SCAPE LANDSCAPE ARCHITECTURE DPC

NEWTOWN CREEK

VERNON BLVD STREET END

**STREET END
REVISED PROPOSAL**

FLOOD MAP

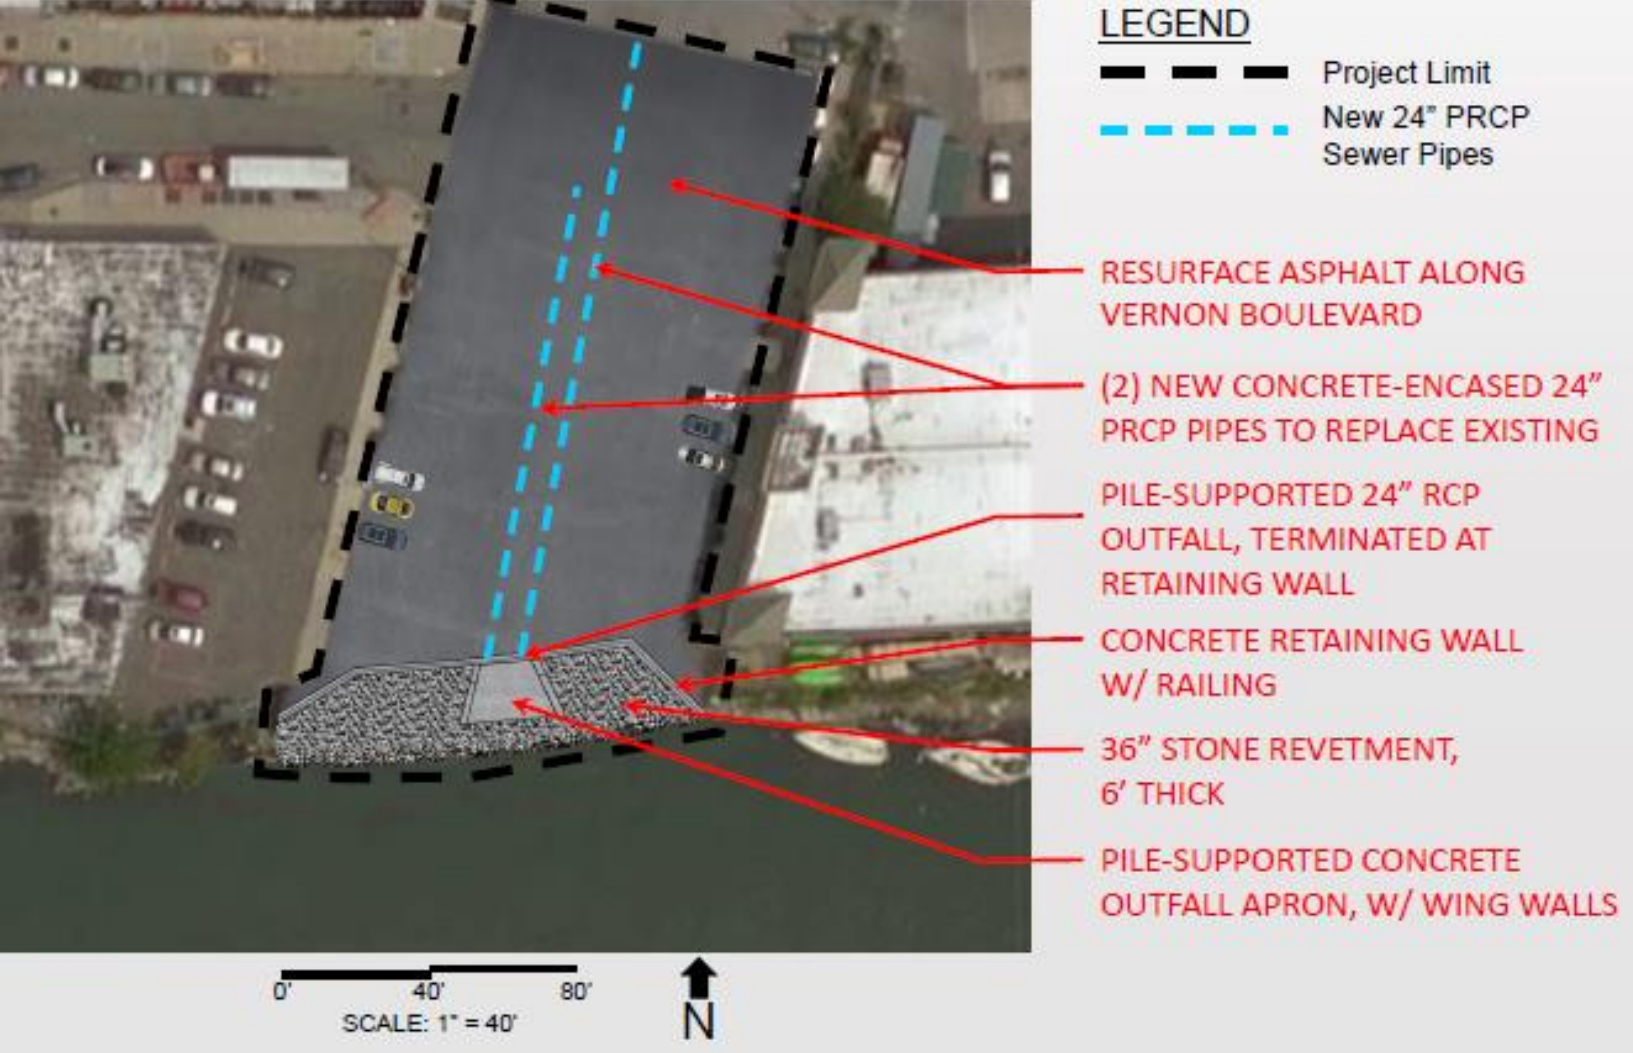
THE VERNON BLVD STREET END IS IN THE FLOOD PLAIN, WITH OR WITHOUT A WALL

NEGATIVE EFFECTS OF A TALL CONCRETE WALL:

- **INHIBITS PUBLIC ACCESS AND VIEWS TO THE CREEK FROM VERNON BLVD**
- **IT WILL NOT STOP WATER FROM FLOWING AROUND EITHER SIDE**
- **FLOOD WATERS WILL POOL UP BEHIND THE WALL, MAKING STORMWATER MANAGEMENT DIFFICULT**

SECTION CUT KEY PLAN

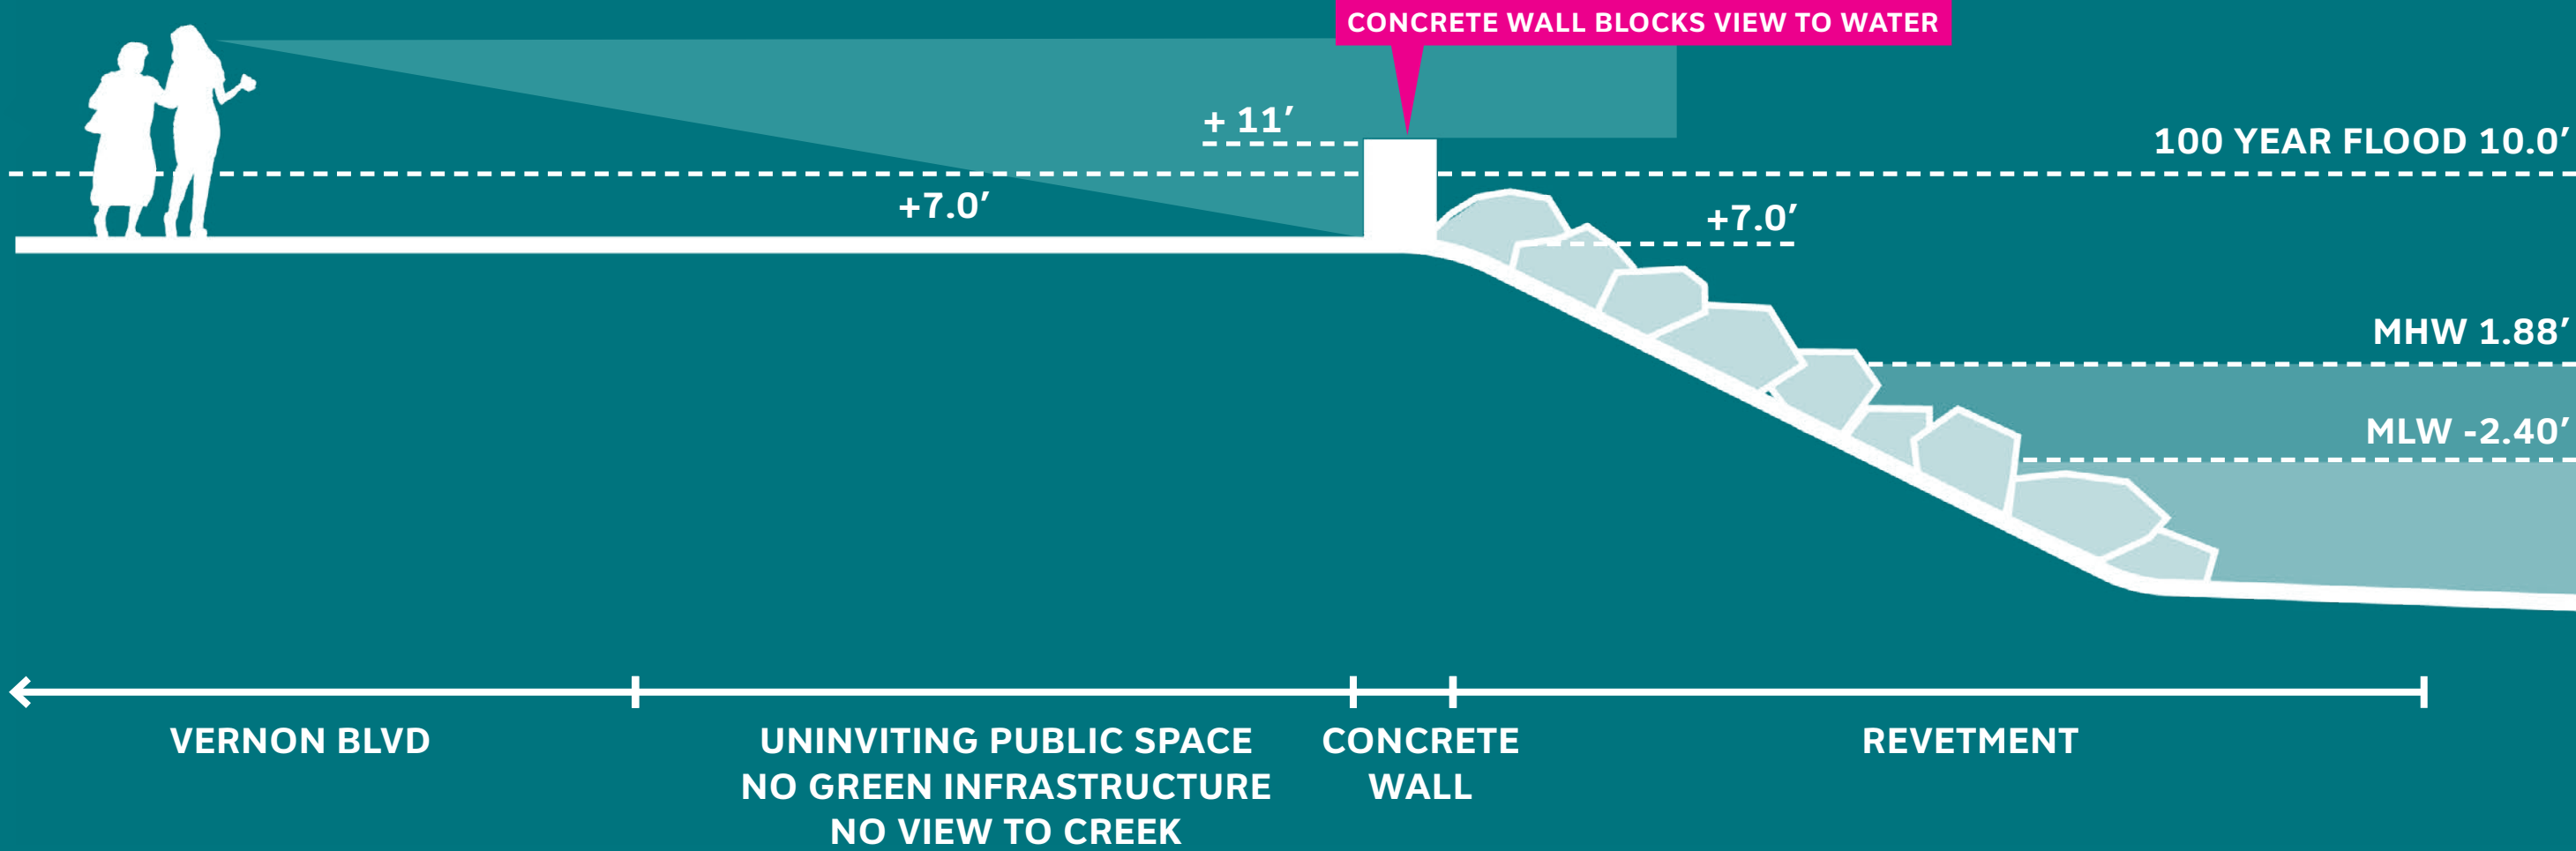
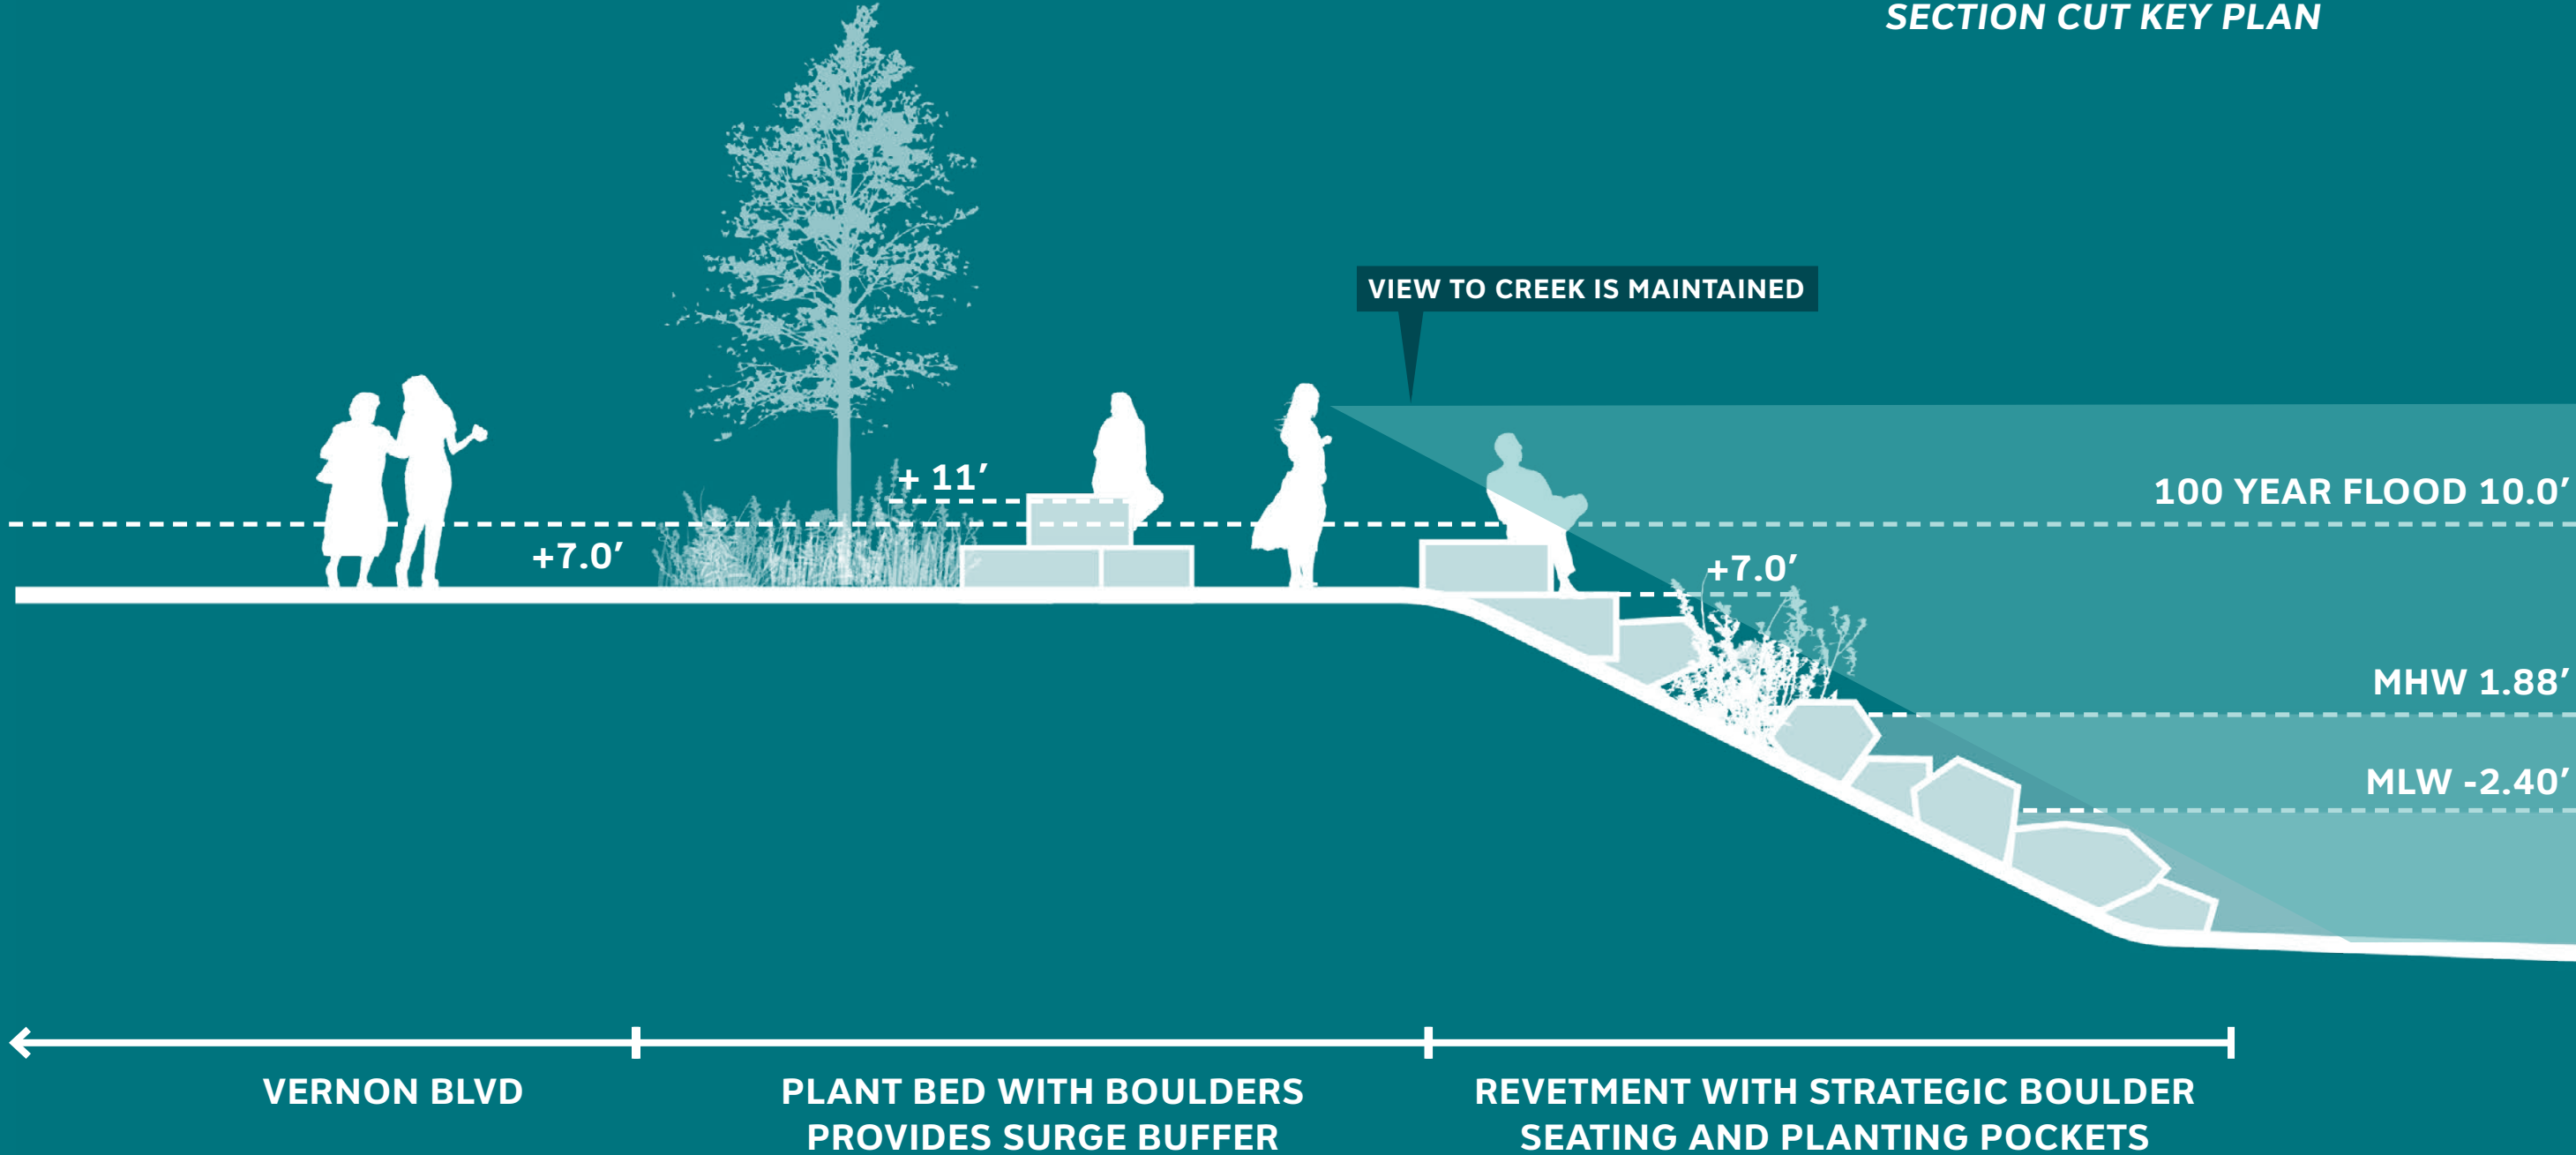
** VERNON BLVD IS A VISUAL CORRIDOR TO NEWTOWN CREEK AND A TALL CONCRETE WALL WILL BECOME A SEVERE OBSTRUCTION*

* VISUAL CORRIDOR TO NEWTOWN CREEK IS MAINTAINED

REVISED PROPOSAL - VIEW FROM CREEK

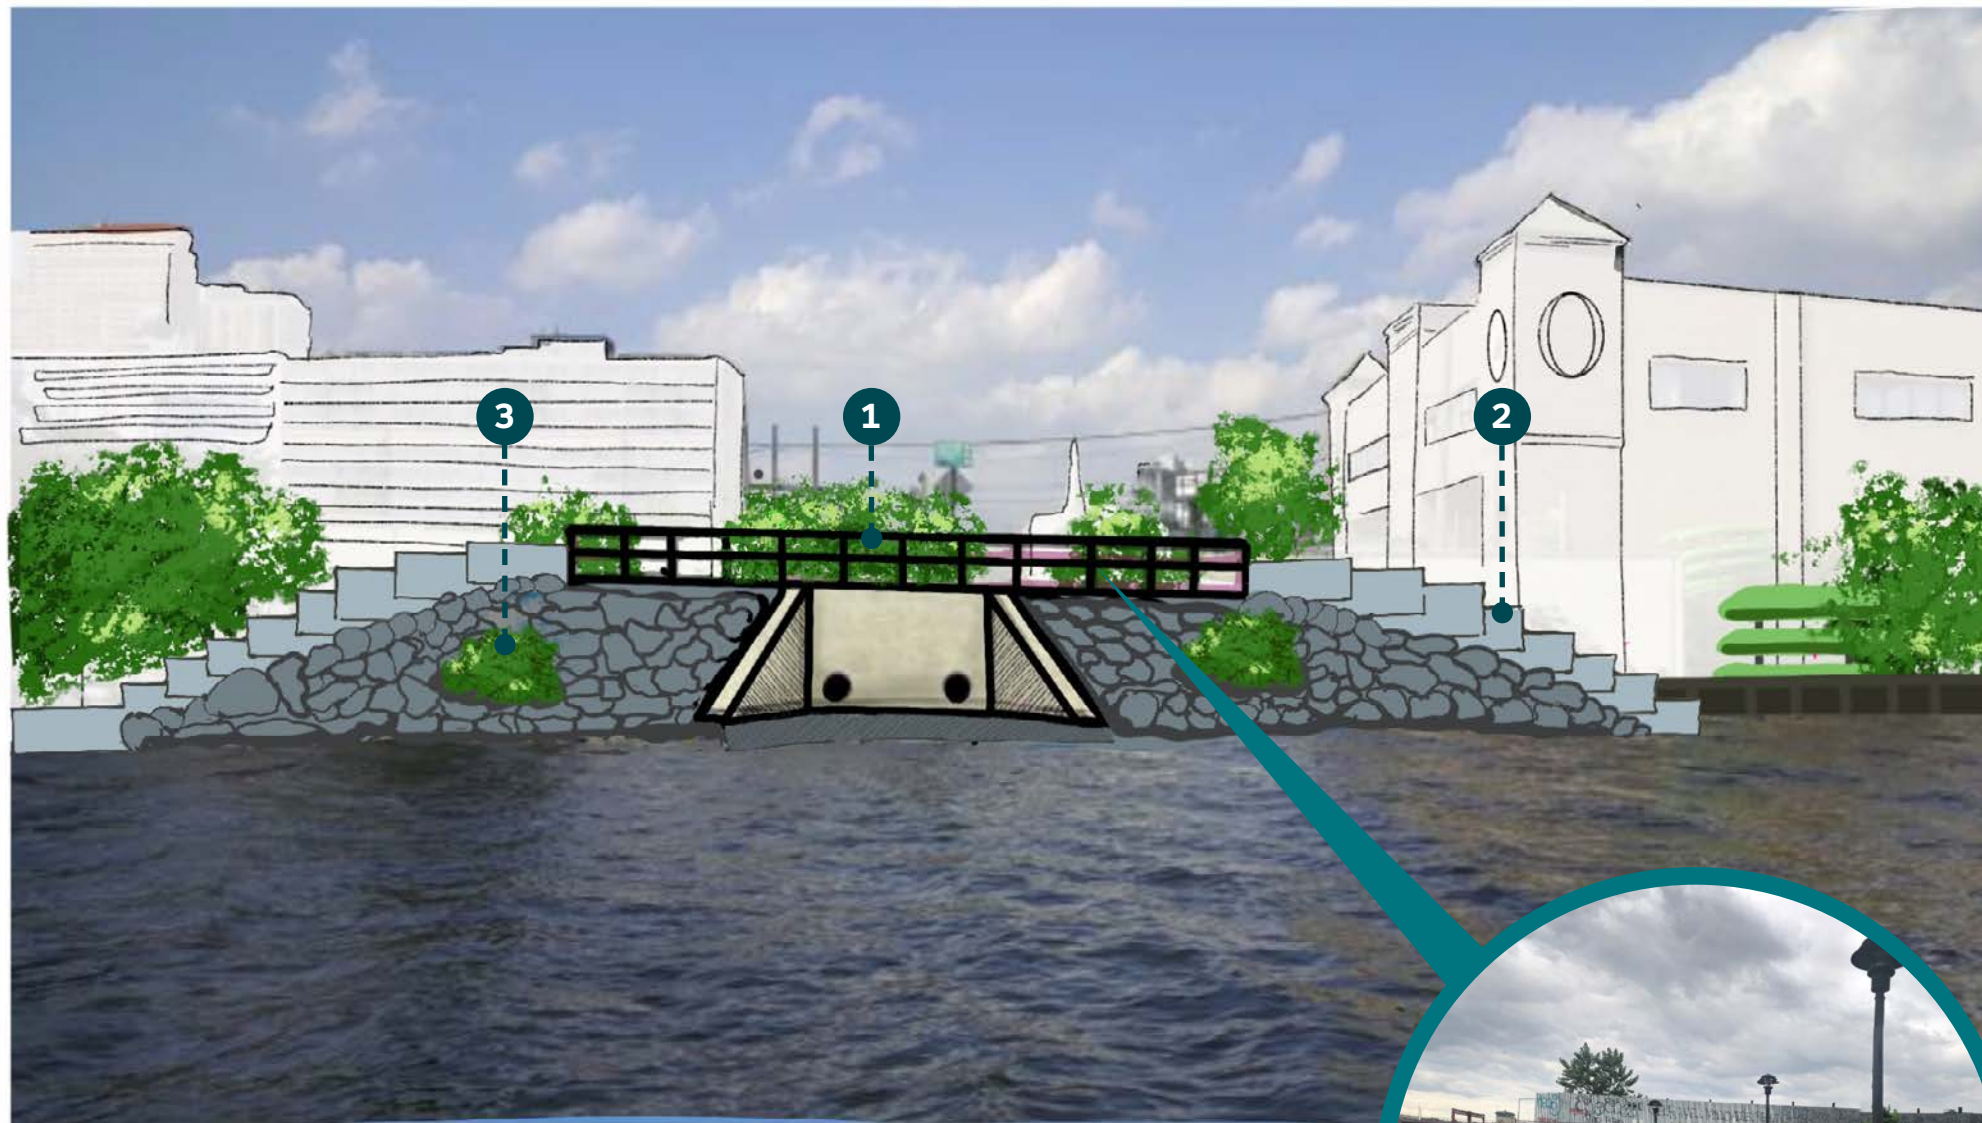
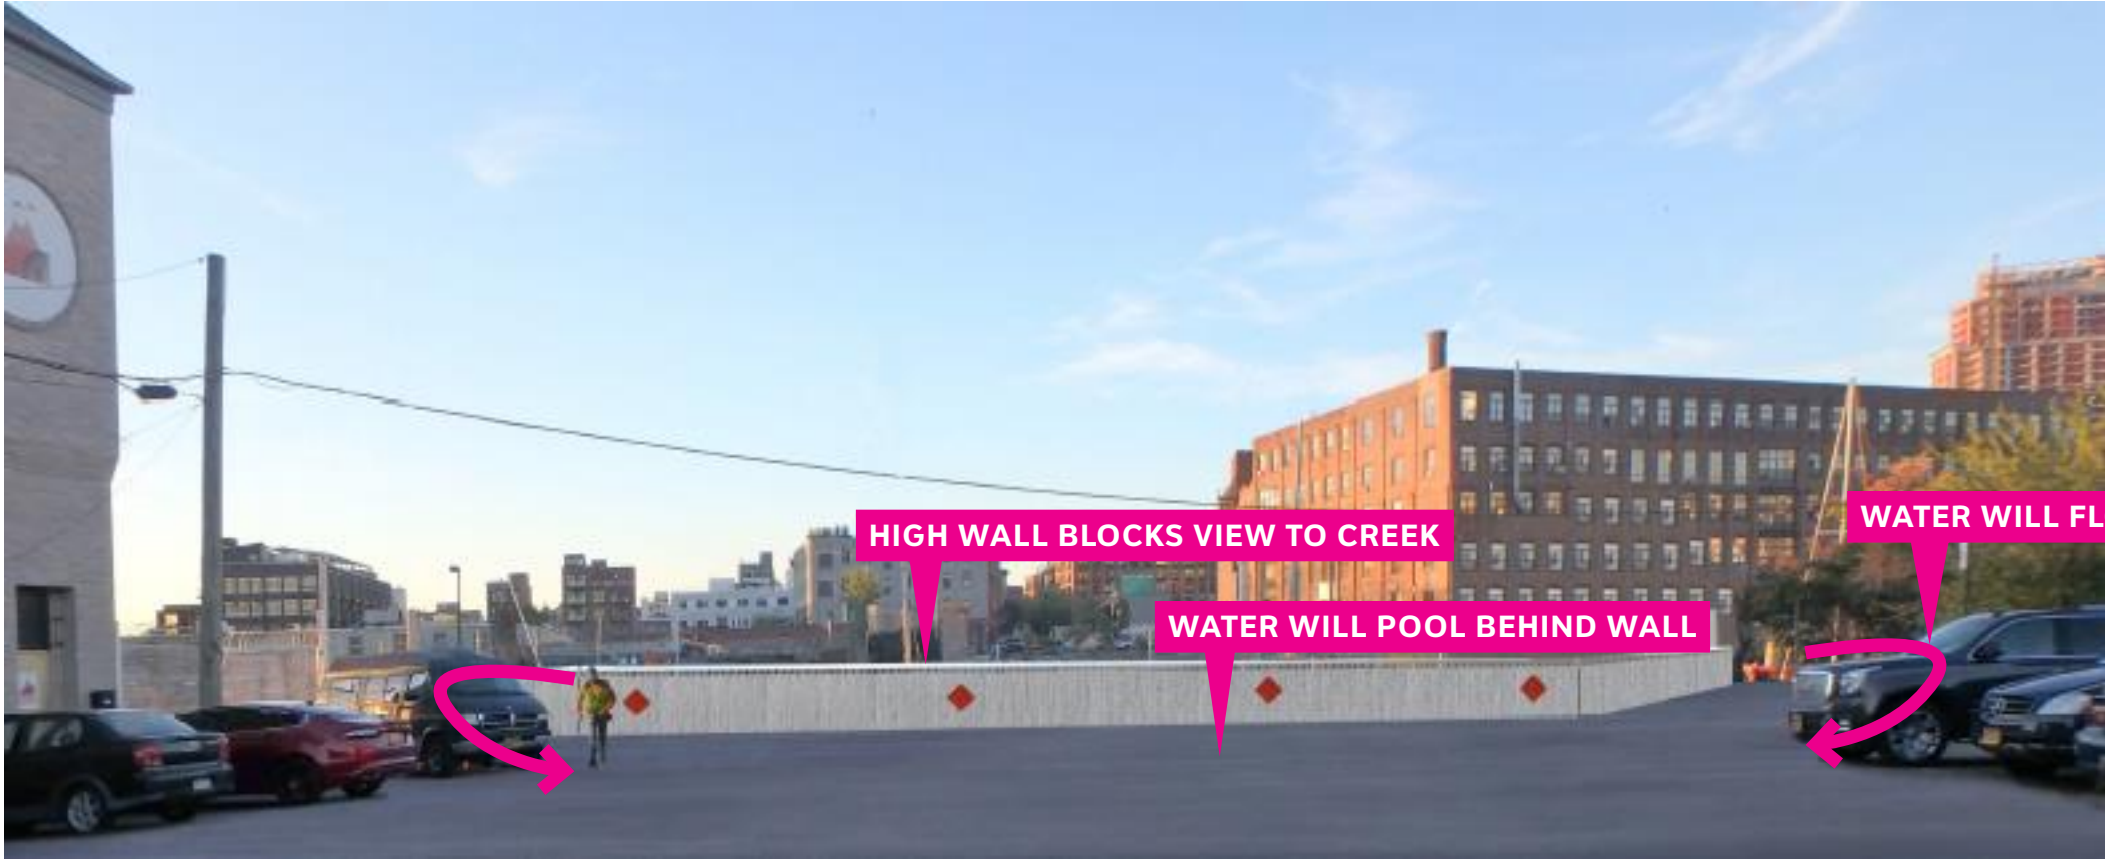
- A RETAINING WALL IS NOT NEEDED ALONG THE ENTIRE LENGTH
- THE EXCESSIVELY TALL HEIGHT CREATES AN EXTREME TRANSITION TO LOW BULKHEADS ON EITHER SIDE AND LIMITS POTENTIAL FOR FUTURE PUBLIC CREEK ACCESS

1. LOWER WALL AND ADD DOT STANDARD GUARDRAIL TO MAINTAIN VIEWS TO NEWTOWN CREEK
2. REDUCE LENGTH OF RETAINING WALL AND USE STACKED BOULDERS TO EASE TRANSITION TO ADJACENT, LOW BULKHEADS
3. PLANTING POCKETS WITH COASTAL SPECIES (*BACCHARIS HALMIFOLIA*) ABOVE HIGH TIDE PROVIDE WILDLIFE HABITAT, FILTER POLLUTANTS, EROSION CONTROL, AND SCREEN THE STREET FROM WATERFOWL IN THE CREEK
